SERVICE BULLETIN #56

SUBJECT: Fuel Primer Pump

APPLICABILITY: Kitfox Lite

Figure 1

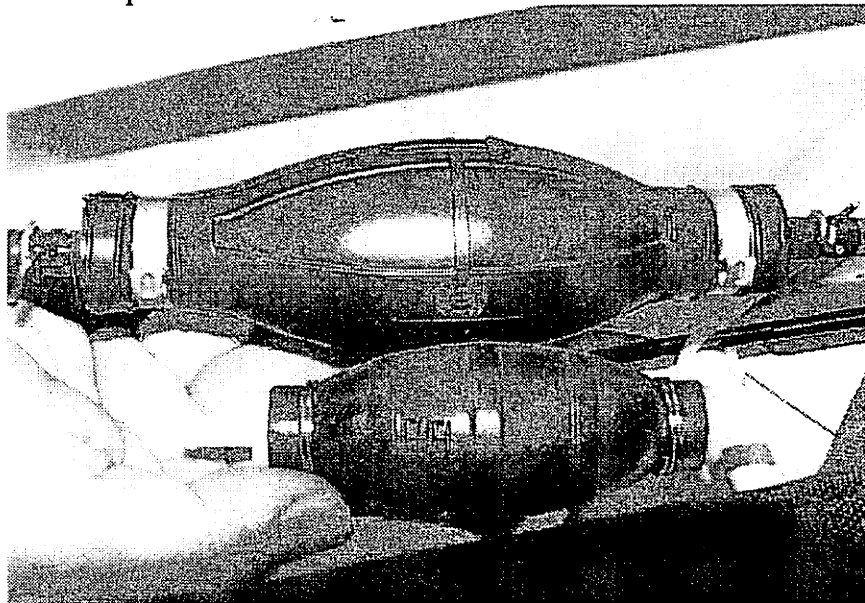
SkyStar Aircraft has shipped two styles of fuel primer pumps for the Kitfox Lite, a large one and a small one. We have discovered the small one has a tendency to leak which could result in a hazardous condition. SkyStar is recalling the small fuel primer pump at this time. Figure 1 shows the large one installed and the small one next to it.

ACTION: Inspect the fuel primer pump that is installed in your aircraft or still in your kit. If you have the incorrect one, please return it to SkyStar with reference to Service Bulletin #56. Upon receipt we will send a replacement.
